**UNITED STATES ENVIRONMENTAL PROTECTION AGENCY**

Re: PCB Cleanup and Disposal Approval under 40 CFR §§ 761.61(a) and (c)  
Former Strawberry Hill Tank Site  
39 Prospect Avenue  
Hull, Massachusetts  
MassDEP RTN: 4-22776

### PCB CLEANUP AND DISPOSAL APPROVAL CONDITIONS 39 PROSPECT AVENUE (“the Site”) HULL, MASSACHUSETTS

Attachment 2: Figure 5 Site Disposal Areas

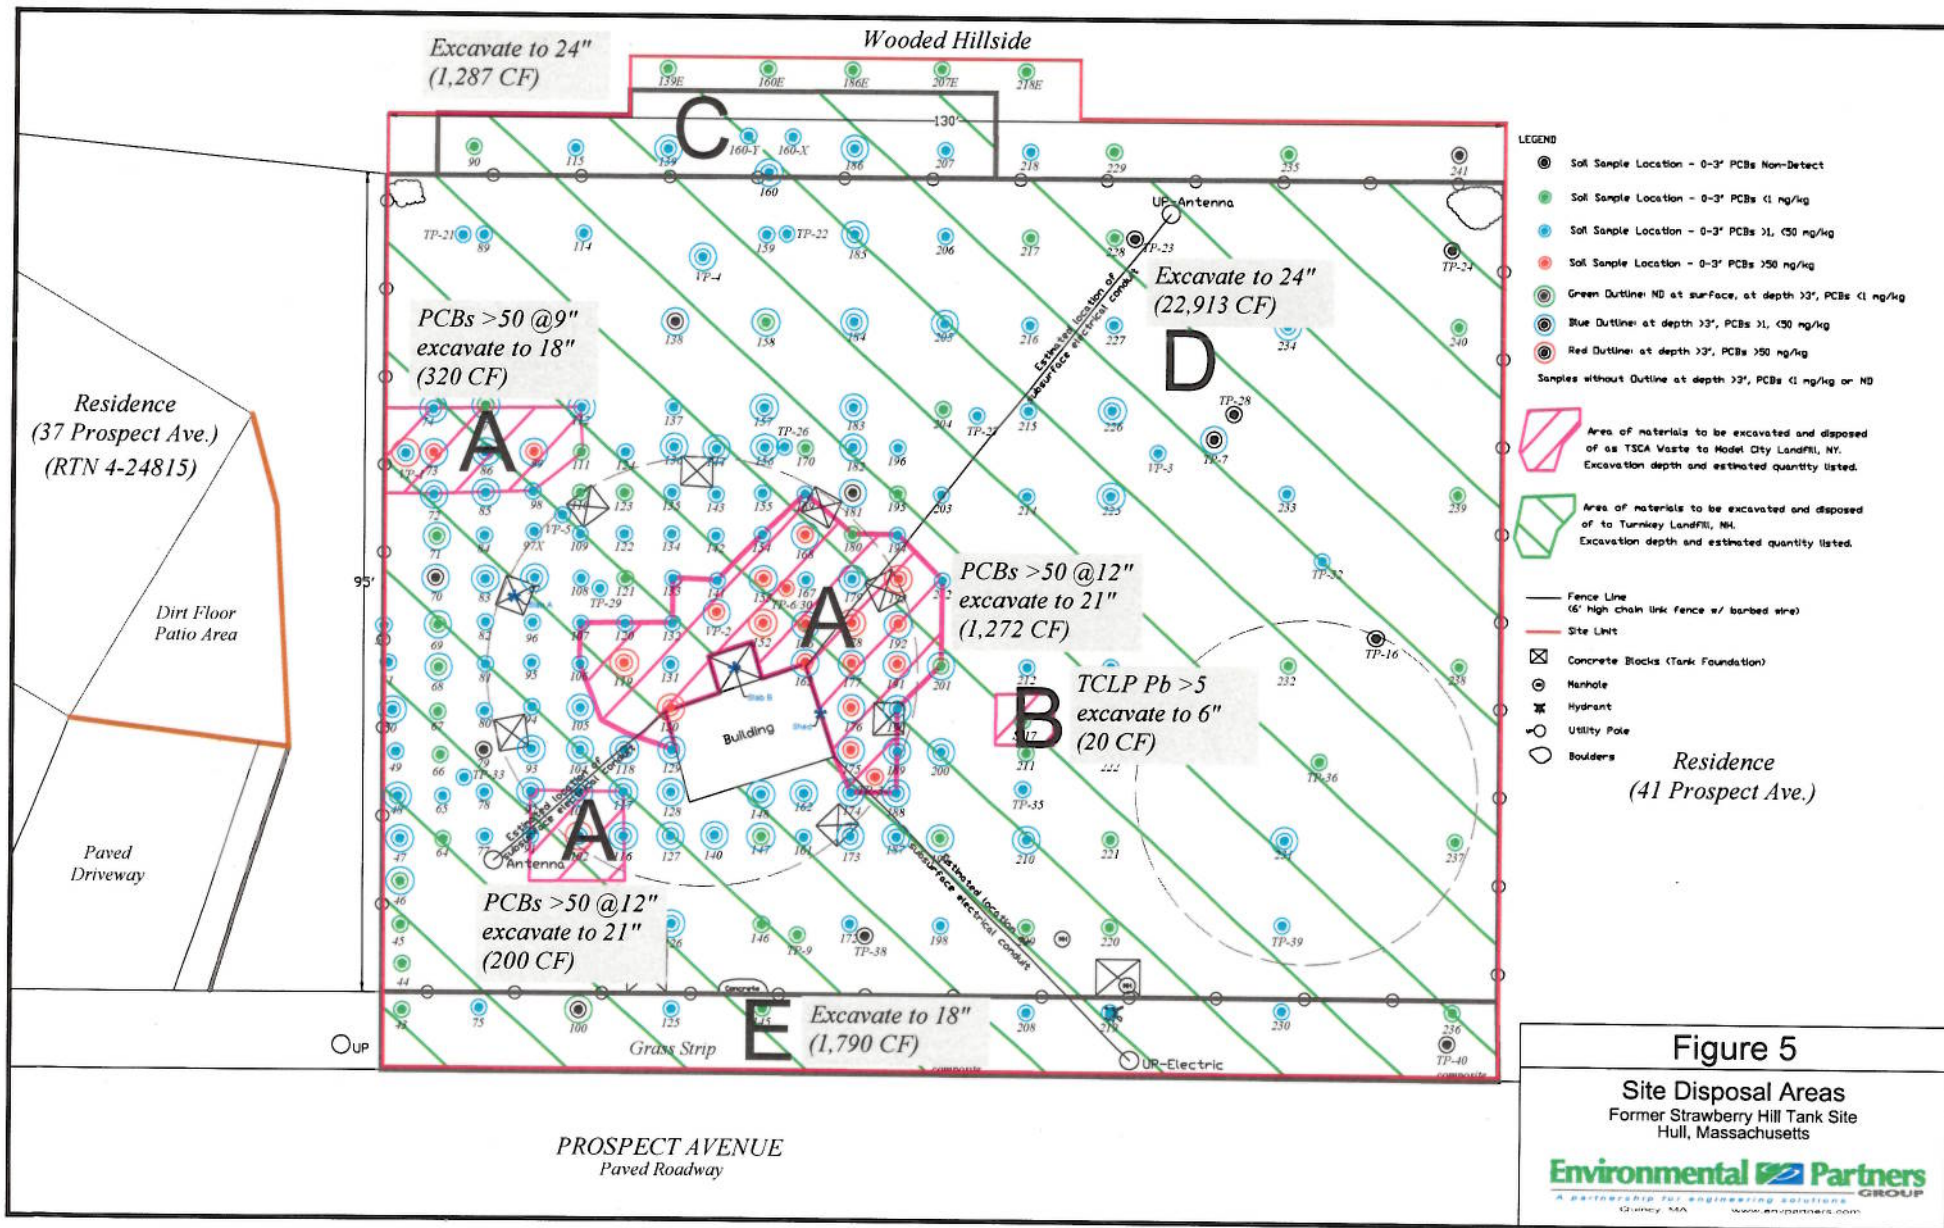
- Remove PCB-contaminated soil and debris located in three areas of the Site (see Attachment 2) and dispose as greater than or equal to ("≥") 50 parts per million ("ppm") *PCB remediation waste* at a TSCA-approved disposal facility or a RCRA hazardous waste landfill in accordance with 40 CFR § 761.61(a)(5)(i)(B)(2)(iii)

- Remove PCB-contaminated soil and debris with greater than (“>”) 1 ppm and less than (“<”) 50 ppm and dispose at a facility permitted by a State to manage non-hazardous waste in accordance with 40 CFR § 761.61(a)(5)(i)(B)(2)(ii)
- Conduct verification sampling in accordance with 40 CFR Part 761 Subpart O to confirm that the less than or equal to (“≤”) 1 ppm PCB standard has been met

- 13. The cleanup level for *PCB remediation waste* at the Site shall be less than or equal to (" $\leq$ ") 1 part per million ("ppm") to meet the requirements at 40 CFR § 761.61(a)(4) for a *high occupancy area* without further conditions.
